**BEFORE THE PUBLIC SERVICE COMMISSION
OF THE STATE OF MISSOURI**

In the Matter of Union Electric Company)
d/b/a Ameren Missouri's 2nd Filing to)
Implement Regulatory Changes in) File No. EO-2015-0055
Furtherance of Energy Efficiency as)
Allowed by MEEIA)

CHANGE REQUEST FOR ADJUSTMENTS TO THE FINAL EM&V REPORT

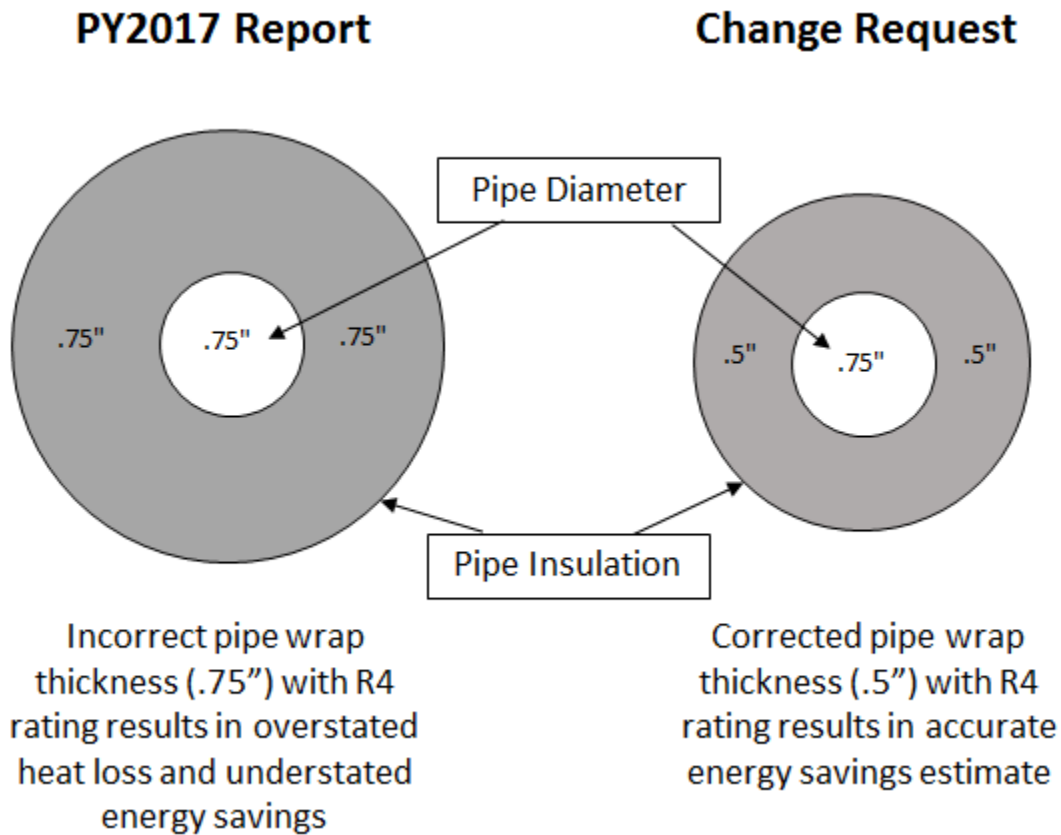
The savings calculated using this equation are dependent upon the circumference of the pipe with and without the pipe wrap, C_{EE} and C_{Base} , respectively. A larger circumference results in a larger surface area, and higher heat loss. This is demonstrated in the graphic below, which shows the same 0.75" inch pipe with both 0.75" thick pipe wrap and 0.5" thick pipe wrap.

12. On page 40 of the EEK Evaluation, the definition of C_{EE} is equal to the circumference of the insulated pipe in feet – calculated as the diameter in inches multiplied by π divided by 12. In Table 29 on page 41 of the EEK Evaluation, the circumference is 0.589 for both School Kits and Multifamily Kits. In order for this to be correct, and with a pipe diameter of 0.75 inches, the thickness of the pipe wrap would have to be 0.75 inches:

$$(.75 + 2*.75)*\pi/12 = 0.589$$

Both the School Kits and the Multifamily Kits that Ameren Missouri distributes contain pipe wrap with a thickness of 0.5 inches. Adjusting the PY2017 pipe wrap savings to account for correcting the pipe wrap thickness would change the first year energy and demand savings reported in the EEK Evaluation as follows:

MWh	EM&V Reported		Change Request		Diff from PY2017	
	Ex Post Gross	Ex Post Net	Ex Post Gross	Ex Post Net	Ex Post Gross	Ex Post Net
School Kits Pipe Wrap	122	128	163	171	41	43
Multifamily Pipe Wrap	11	11	14	14	3	3
Pipe Wrap Total	133	139	177	185	44	46

kW	EM&V Reported		Change Request		Diff from PY2017	
	Ex Post Gross	Ex Post Net	Ex Post Gross	Ex Post Net	Ex Post Gross	Ex Post Net
School Kits Pipe Wrap	11	11	14	15	4	4
Multifamily Pipe Wrap	1	1	1	1	0	0
Pipe Wrap Total	12	12	16	16	4	4
